M e m o r a n d u m

Date: 7 January 2013
To: John Cushing, Cascade Corporation
Copies to: Charlie Andrews, SSPA
From: Joey Hickey, Cindy Bartlett, Brent Miller
Subject: TGA Remedy: Shepard Springs Realignment Project Completion
Geosyntec Project: PNG0564G

SHEPARD SPRING DRAINAGE PROJECT
 NEW WORK SCHEMATIC ELEVATIONS FOR
 NMH-1 AND SV - "AS BUILT"
 TGA REMEDY
 EAST MULTNOMAH COUNTY

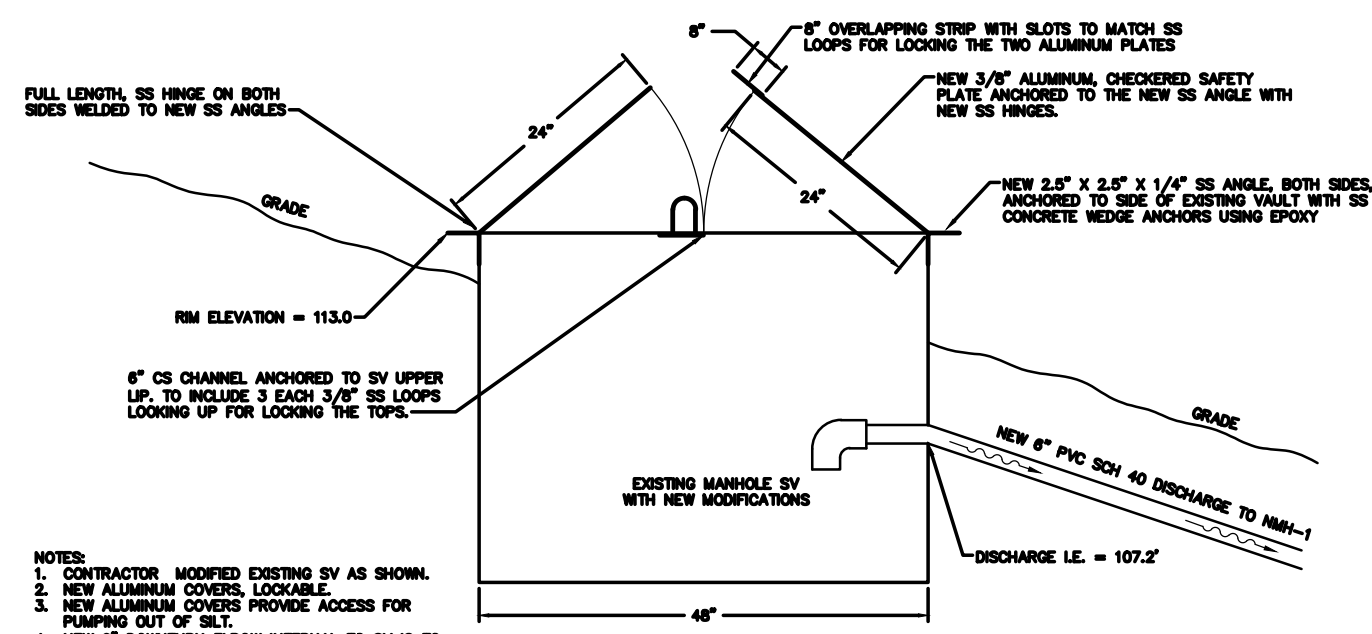
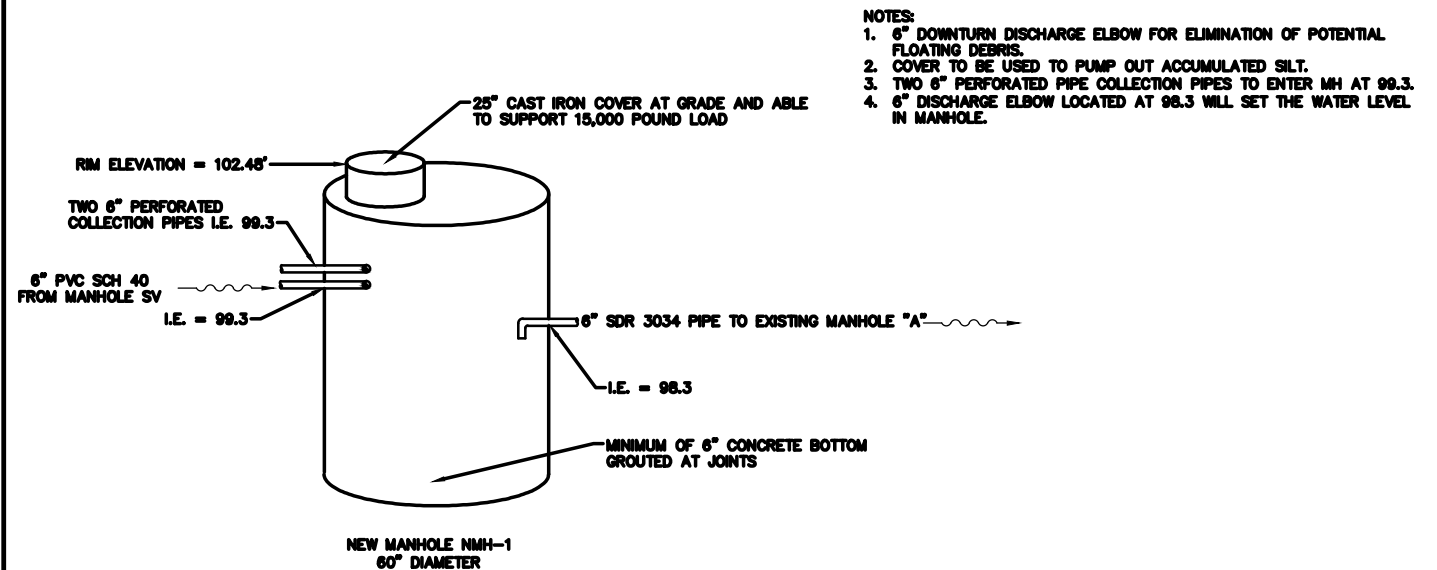
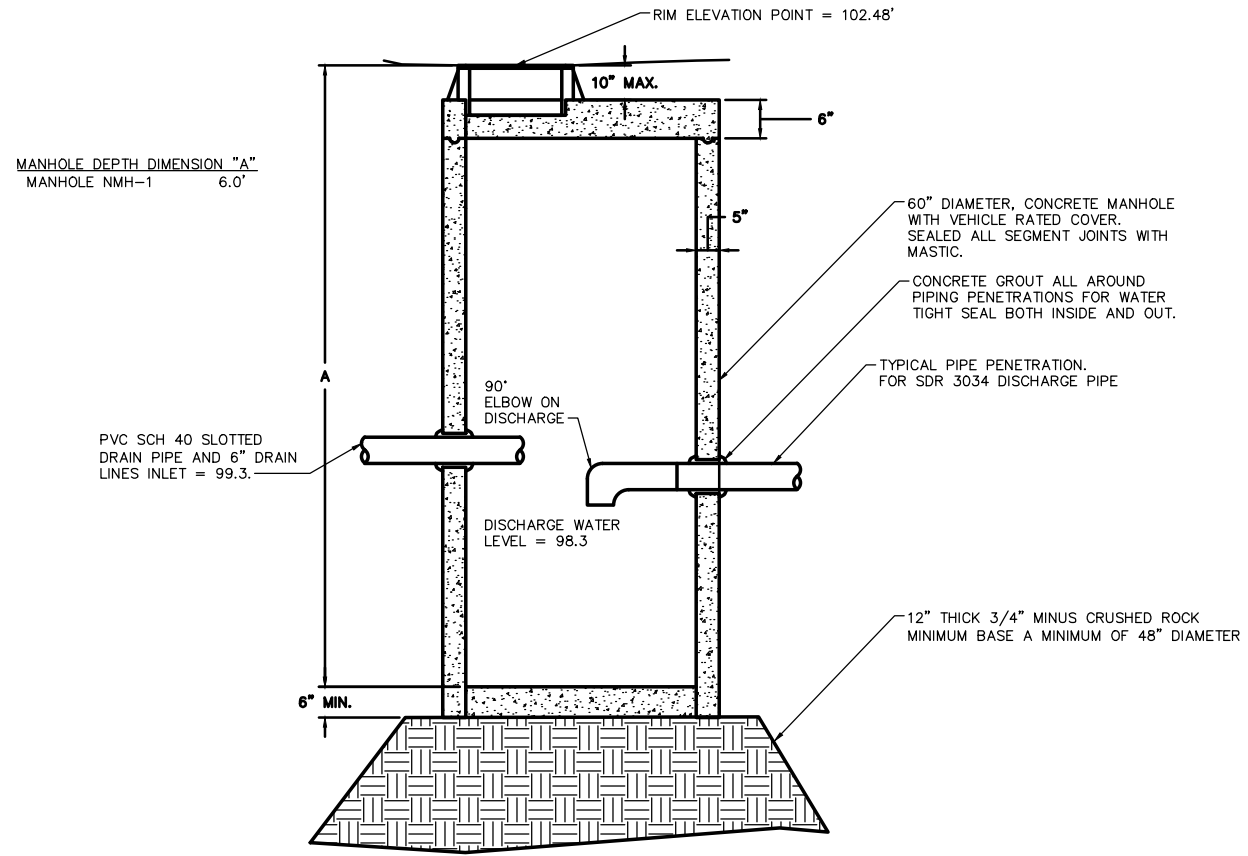
- During the placement of the piping runs from the existing square vault (SV) and the new manhole (NMH-1), one poplar tree was removed to allow access for the excavation equipment. The felled tree was staged on Site near the CTS.
- The new 6-inch drain pipe from SV to NMH-1 was changed to Schedule 40 PVC from C900 pipe.
- The original drawings called for NMH-1 to be 48-inches in diameter. Due to product availability, a 60-inch diameter manhole was used.

NOTES:
 1. CONTRACTOR MODIFIED EXISTING SV AS SHOWN.
 2. NEW ALUMINUM COVERS, LOCKABLE.
 3. NEW ALUMINUM COVERS PROVIDE ACCESS FOR PUMPING OUT OF SILT.
 4. NEW 6" DOWNTURN ELBOW INTERNAL TO SV IS TO PREVENT FLOATABLES FROM ENTERING DISCHARGE LINE TO NMH-1.

SHEPARD SPRING DRAINAGE PROJECT DETAILS "AS BUILT" TGA REMEDY EAST MULTNOMAH COUNTY	
PORTLAND, OR	DECEMBER 2013
FIGURE: C4.0

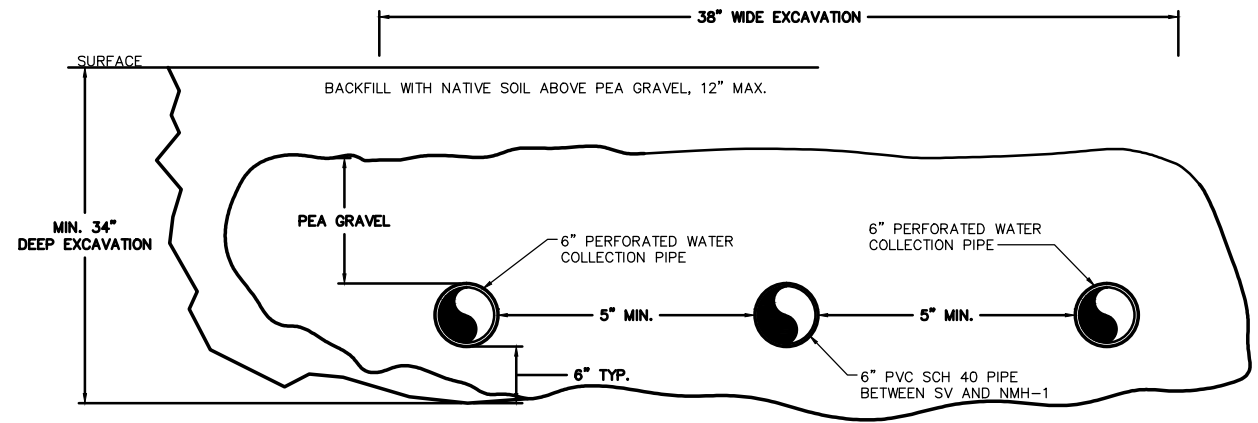
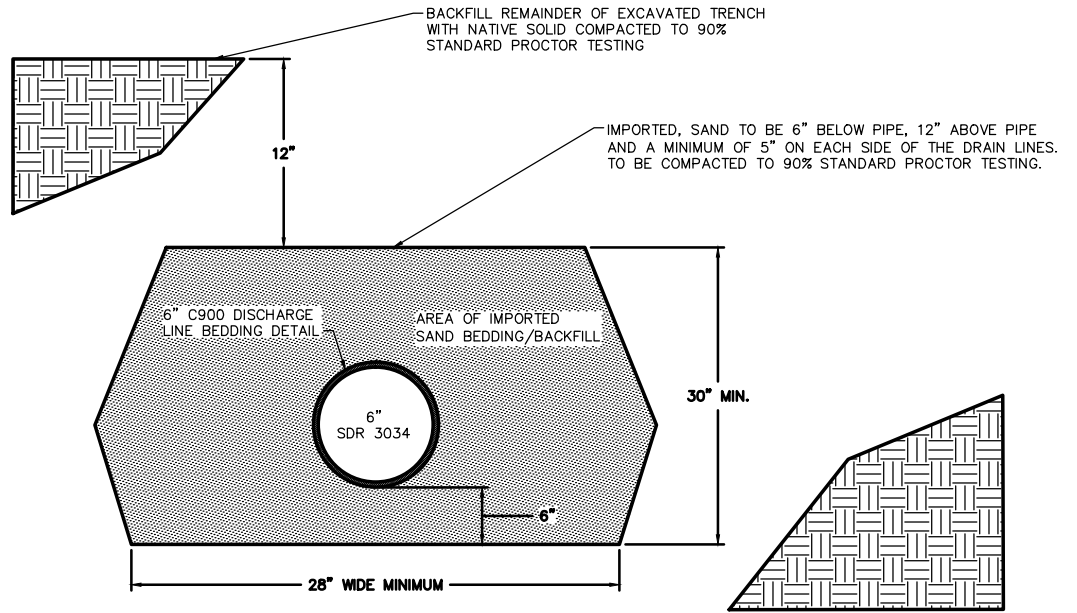
- The original drawings noted the use of a minimum of 12-inches of crushed rock to cover the piping from SV to MNH-1. After approval of the plans, Geosyntec realized that a design specification (size, presence of fines, etc.) had not been prepared for the crushed rock. The concern was that if standard ¾-minus rock was used, drainage would be limited due to compaction issues. It was determined that the use of pea-gravel would be used to backfill the 6-inch drain line and the two 6-inch perforated collection pipes.

- NOTES:
1. EXCAVATED A MINIMUM OF 38" WIDE BY 30" DEEP FOR PIPING.
 2. BEDDED ALL PIPES WITH 6" OF PEA GRAVEL.
 3. COVERED PERFORATED PIPE AND CONVEYANCE PIPE WITH AT LEAST 12" Ø PEA GRAVEL.
 4. BACKFILLED WITH NATIVE SOIL TO ORIGINAL GRADE.

SHEPARD SPRING DRAINAGE PROJECT SYSTEM MODIFICATIONS "AS BUILT" TSA REMEDY EAST MULTNOMAH COUNTY	
	FIGURE: C3.0
PORTLAND, OR	DECEMBER 2013

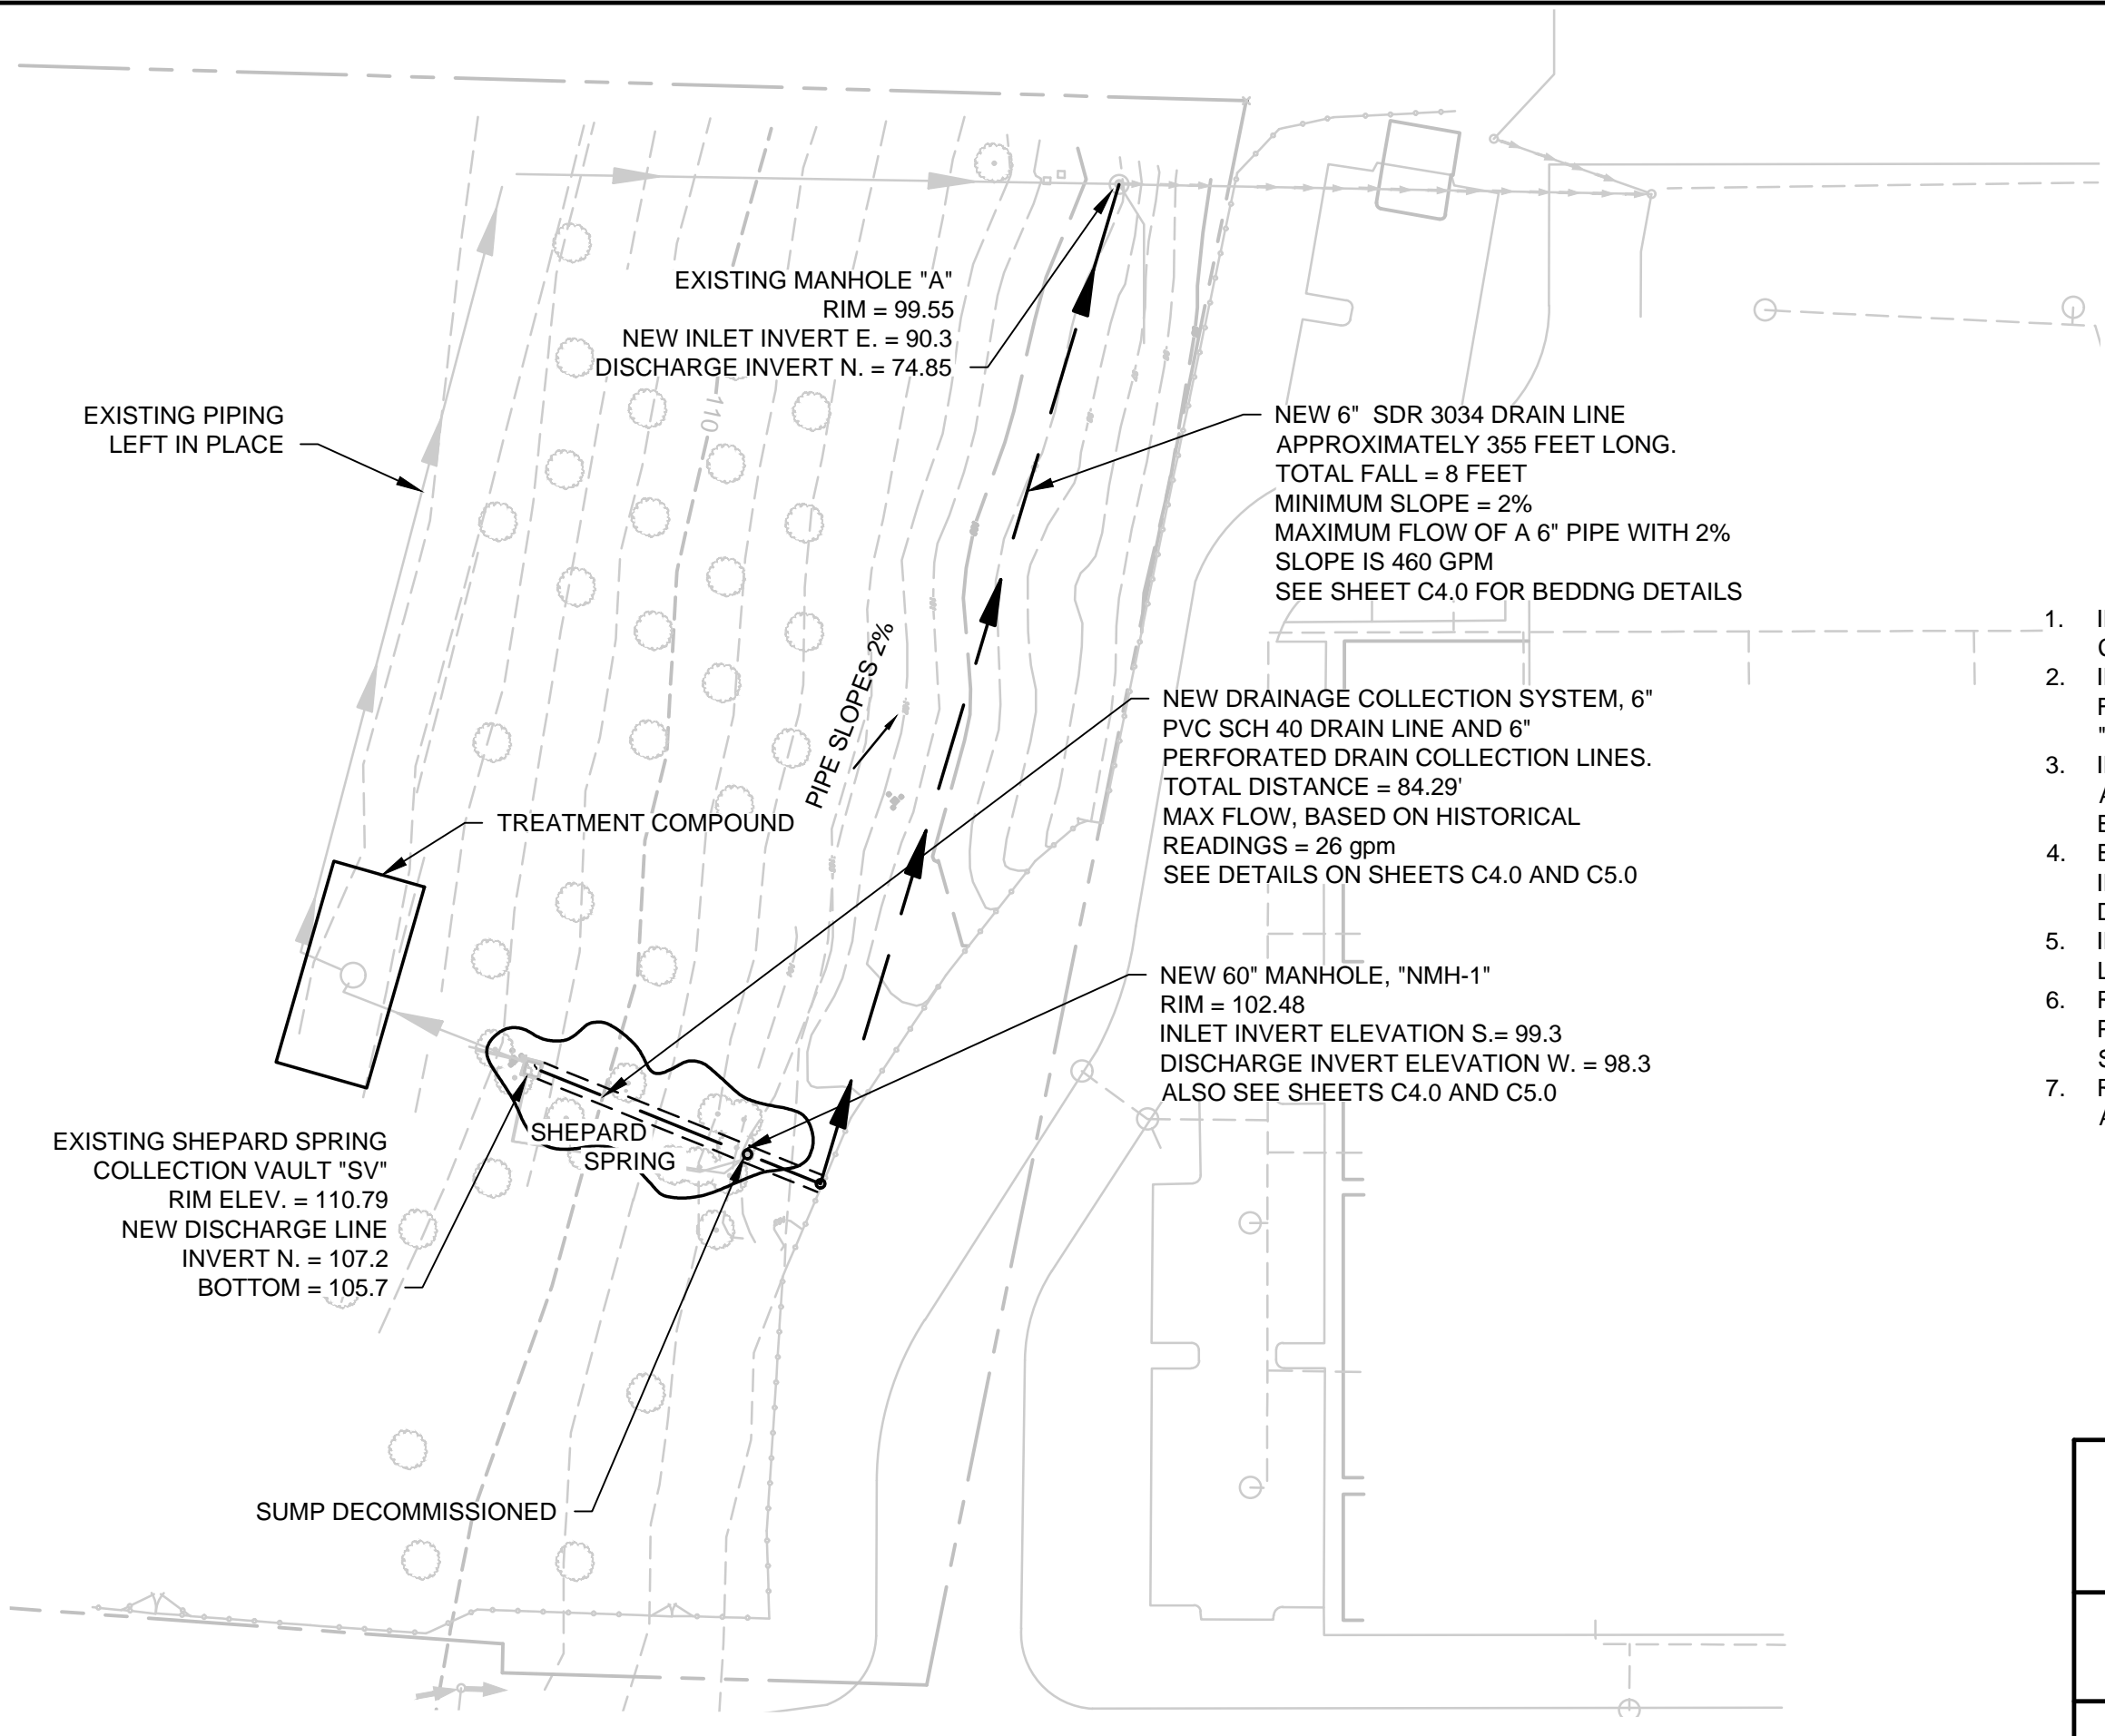
- The proposed location of NMH-1 was moved 9-feet north. The movement of NMH-1 was necessary to provide a straight piping run from NMH-1 to existing manhole “A”. The movement of the manhole allowed the new piping run to avoid MW-46.

- The original drawings called for the use of C900 pipe from NMH-1 to existing manhole “A”. After the approval of the design, the City and AEC noted that the use of SDR 3034 (storm drain line) was acceptable and more cost effective. As such, the 6-inch line from NMH-1 to existing manhole “A” was constructed with SDR 3024 pipe.

1. INSTALLED 60" MANHOLE, "NMH-1", WITH CAST IRON COVER SUITABLE FOR VEHICLE TRAFFIC.
2. INSTALLED 6", PVC SCH 40 GRAVITY DRAIN LINE FROM EXISTING VAULT "SV" TO NEW MANHOLE, "NMH-1".
3. INSTALLED 6", SDR 3034 GRAVITY DRAIN LINE WITH A TYPICAL 2% SLOPE FROM MANHOLE "NMH-1" TO EXISTING MANHOLE "A". SEE SHEET C3.0
4. EXCAVATED A MINIMUM OF 28" WIDE TRENCH; INSTALLED NEW SDR 3034 LINES AND BED PER DETAIL ON C4.0
5. INSTALLED 6" PERFORATED DRAIN COLLECTION LINES AS SHOWN ON SHEETS C4.0 AND C5.0.
6. REMOVED EXISTING ABOVE GROUND INSULATED, PVC PIPE SUMP TO EXISTING SQUARE MANHOLE, SV.
7. REMOVED EXISTING PVC PIPE WITH SUMP PUMP AND ELECTRICAL POWER.
